# SM-PMA delay constraints

(comment # 451)

IEEE 802.3dj January 2025 interim meeting

From Table 176-7: Delay constraints *in Draft 1.3*

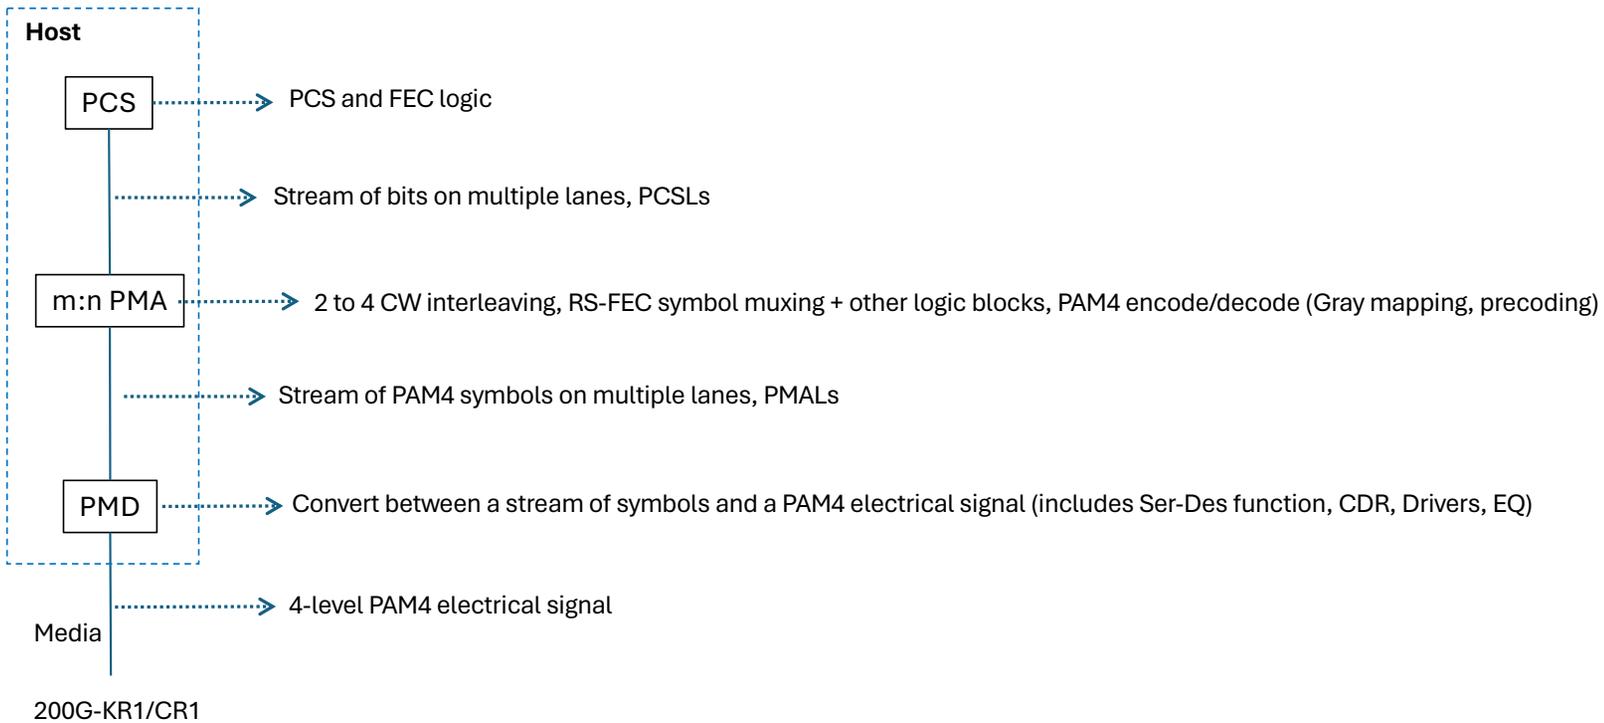
- Table contains numbers for 800GE ==> copied from 802.3df
  - 32:4 PMA delay allocation is same as 32:8 PMA from 802.3df
  - 4:4 PMA delay allocation is same as 8:8 PMA from 802.3df
  - Delay of the 4:4 PMA is 2x of 32:4 PMA
- Other PMA delays - TBD
- 1.6TbE 16:16 PMA not present in Table 176-7

# m:n SM-PMAs: Proposed delay constraints

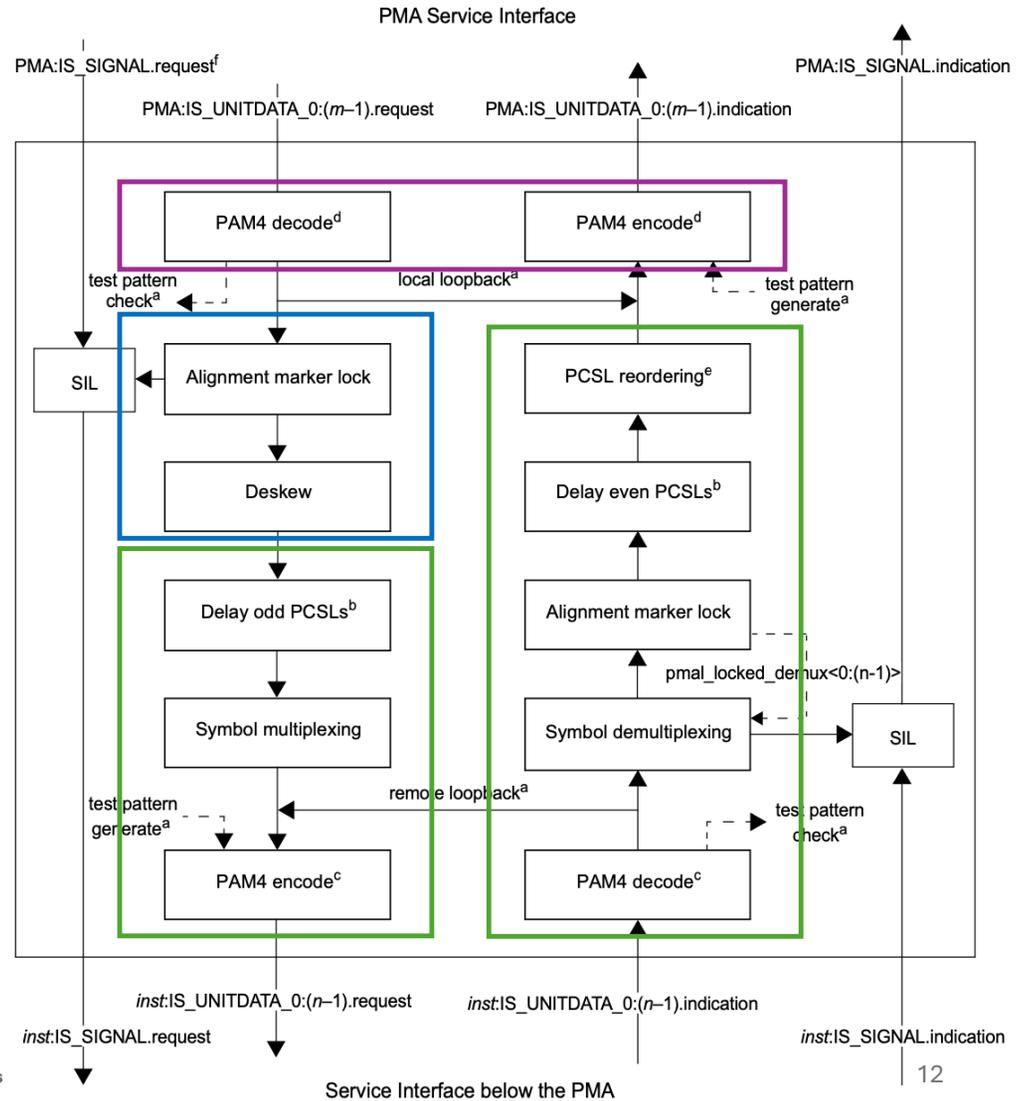
- Delay of alternating lanes (to enable 4 CW interleaving) results in a fixed 2-CW latency for 200/400GE
  - 51.2ns for 200GE
  - 25.6ns for 400GE
  - The 2-CW delay is not applied in the 800GE/1.6TE m:n PMAs
- For the other logic blocks, assume one clock cycle delay per block (plus few extra cycles)
  - A budget of ~ 15 ns (at 1Ghz) is sufficient
  - Round up to 15.36ns = 6 PQ @ 200GE
- Propose following delay constraints:
  - 200GE 8:1 and 1:8 PMA : 15.36 + 51.2 = 66.56 ns
  - 400GE 16:2 and 2:16 PMA: 15.36 + 25.6 = 40.96 ns
  - 800GE 32:4 and 4:32 PMA : 15.36 ns
  - 1.6TE 16:8 and 8:16 PMA : 15.36 ns

# n:n SM-PMAs: Proposed delay constraints

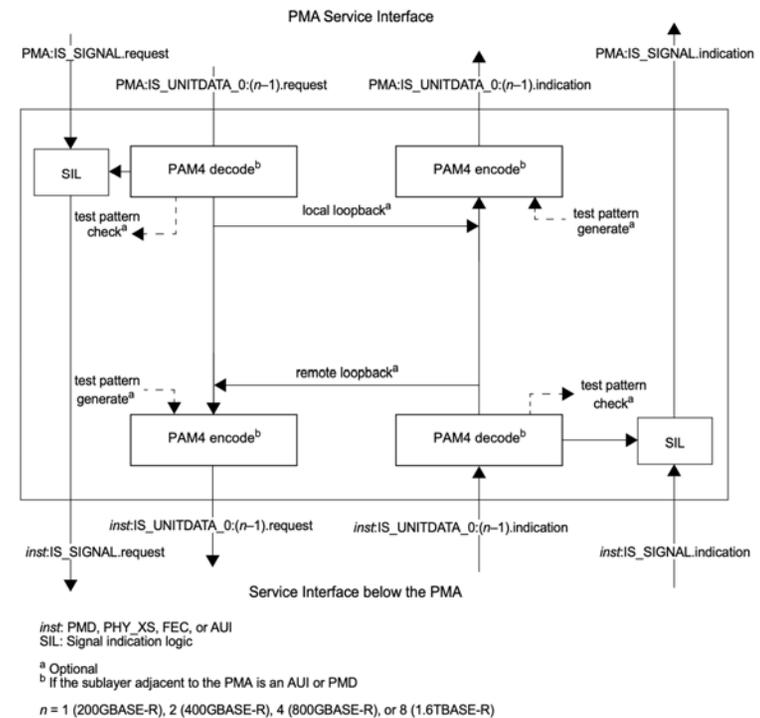
- n:n PMA has back-to-back PAM4 encode/decode functions
  - Other functions typically associated with “Serdes” are in the C2M/G2C component or in the PMD
- Assume one clock cycle for each of the PAM4 encode/decode logic block plus a few additional cycles (6 cycles) between blocks per direction (4 + 6 + 6 = 16 total)
  - Assume budget of ~16ns delay round-trip (1 Ghz clock)
  - Round down to 15.36 ns = 6 PQ @ 200GE
- Propose using 15.36 ns for n:n SM-PMAs
